Re: *Preliminary Subdivision Plat request for Canterbury Crossing*

Responding to the Preliminary Subdivision Request submitted by Prestige Builder Group for the July 8, 2024 Hudson Planning Commission meeting, we generally agree with many of the comments contained within the Staff Report, with certain initial exceptions:

Regarding Case # 2023-676

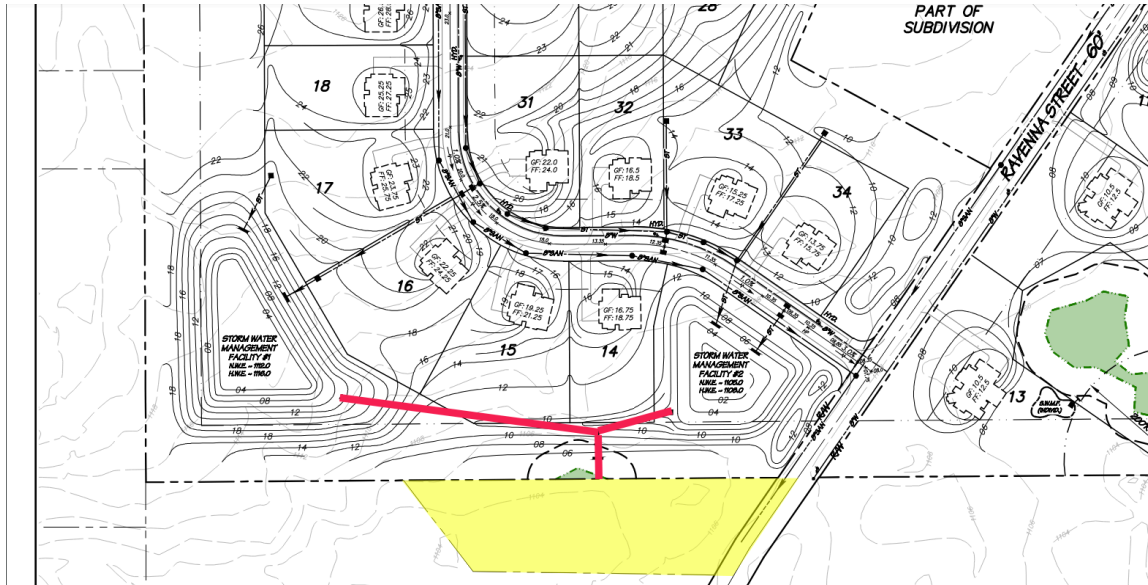
Now, let's discuss stormwater management. If you observe the grading elevations on page 3 of the applicant's site plan (labeled "Utility Plan") you will note that should the ponds ever reach capacity, any water that spills over the banks will travel directly towards my property. This is in direct conflict with Section 1419.05 which requires that major flood paths "... *prevent loss of property or life*".

If you follow the grading lines carefully you will actually find a continuous downward slope from Units 14, 15, 16, 17, 18, 19, 28, 29, 30, 31, 32, 33, and 34 directly towards my dwelling. There is no mounding, no screening, no swales... just lot's of runoff directed at me.

More insultingly, if you zoom all the way to 100%, you will see two pipes leaving Stormwater Management Facility #1 and #2 and converging on my property. The applicant is proposing that you permit them to discharge their stormwater ponds directly onto my property. This is in conflict with Section 660.22 which states that no person shall "... *divert any water or drainage from adjacent lands to or upon any adjacent real property*". I have no agreement with the applicant or the City, and will not permit the discharge of stormwater onto, or through, my property. Who would even maintain the discharges in such a ludicrous proposal - there are no easements.

A city owned stormwater pond is located less than 500 feet west of the project. I propose that adequate mounding should be used on the western border to create both visual screening and a flood swale. Stormwater Management Facilities #1 and #2 should outflow towards Ravenna Street, and then be pipel via the right-of-way to the City owned stormwater pond. The City's Engineering Report states almost exactly the same under General Comment (4)(a).

Piping the water will be critical, it cannot be allowed to flow on the surface as the right-of-way has a higher elevation than my front yard and any water discharged at street level will simply flow back towards my dwelling.

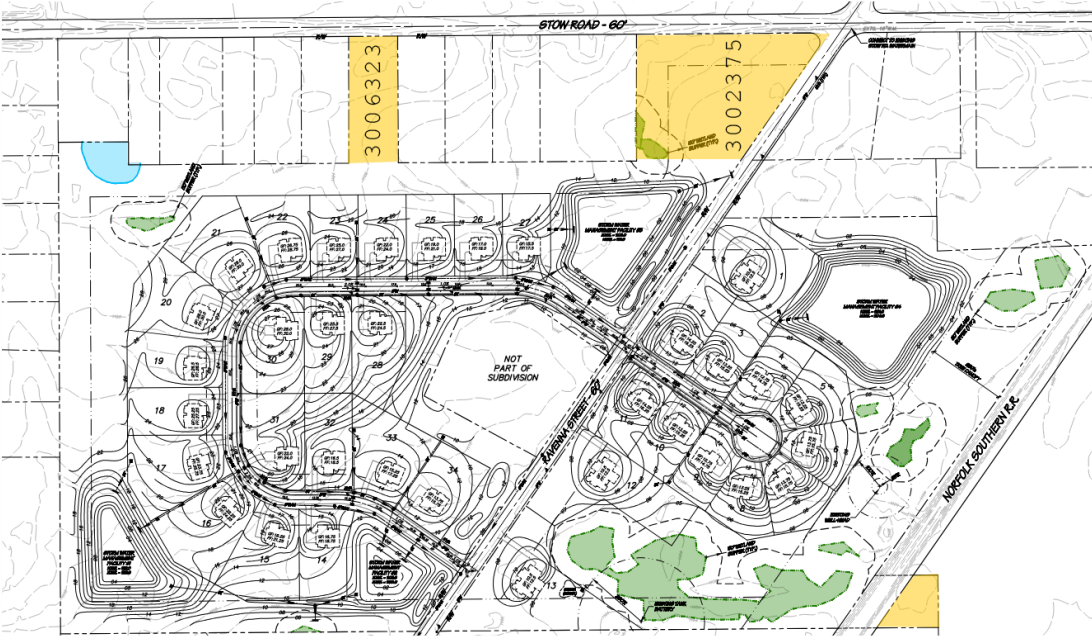
I am happy to see we've finally put the "it's one neighborhood not two" argument to bed. It's clearly two neighborhoods and claiming it was one was a blatant attempt to cheat the density calculations. Unfortunately, we still have several other attempts to cheat the density calculations with us.

Net density as defined in 1201.07(F)(2) is *".. the measure of dwelling units permitted per acre of land area **contained in the development**, excluding streets, easements, public open space, **land under water**, and certified wetlands and floodplains"*. The 5.61 acres contained in parcels 3002375 and 3006323 are clearly not "contained in the development" as illustrated in yellow on the graphic below. No development activity will take place on either of these parcels. In fact, the applicant even uses a similar argument to explain why 0.48 acres of land on parcel 3001397 is excluded from the project. Shouldn't the same reasoning apply to the entirety of parcels 3002375 and 3006323?

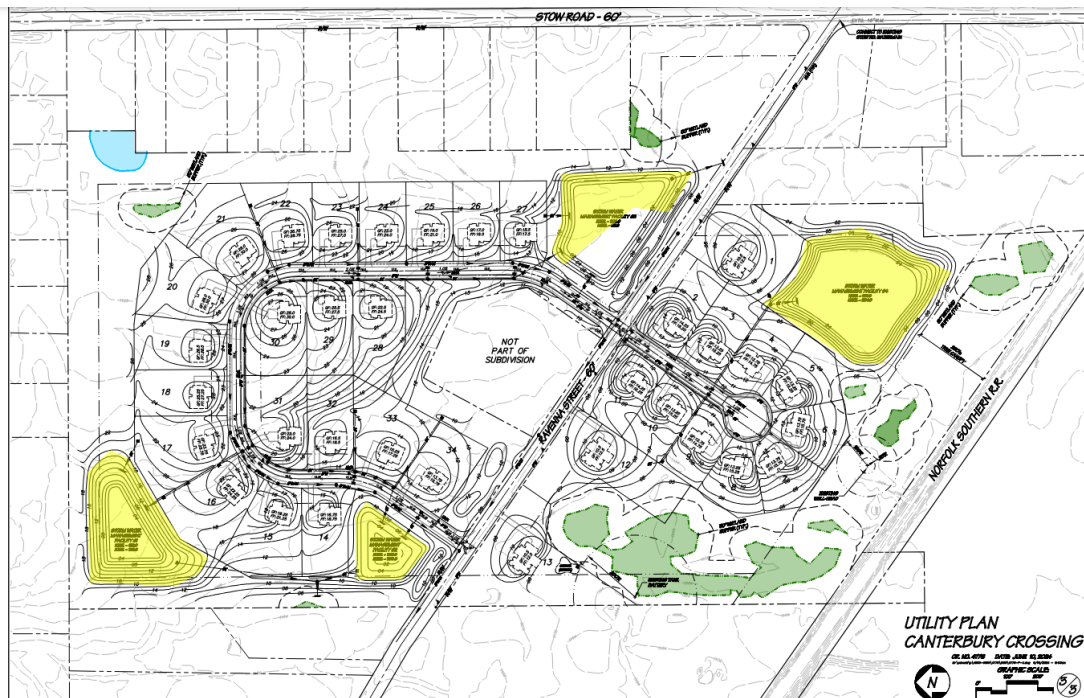
Additionally, the applicant has failed to include new or enlarged stormwater ponds as “land under water”. These new ponds are illustrated in blue on the applicants site plan, and labeled Stormwater Management Facilities #1, #2, #3, and #4. While an exact area was not provided on any drawing that I could find, I think a reasonable estimate is 3 acres on the north, and 2 acres on the south.

Using only the land contained in the development, subtracting the estimated land under water, and using the Rural Residential density of one dwelling per 2.5 acres - you should arrive at 17 units on the north instead of 21, and 11 units on the south, instead of 13. The staff report indicates that public amenities must be incorporated into the final design - which may further reduce the number of allowed units. The detailed math has been provided in Appendix A.
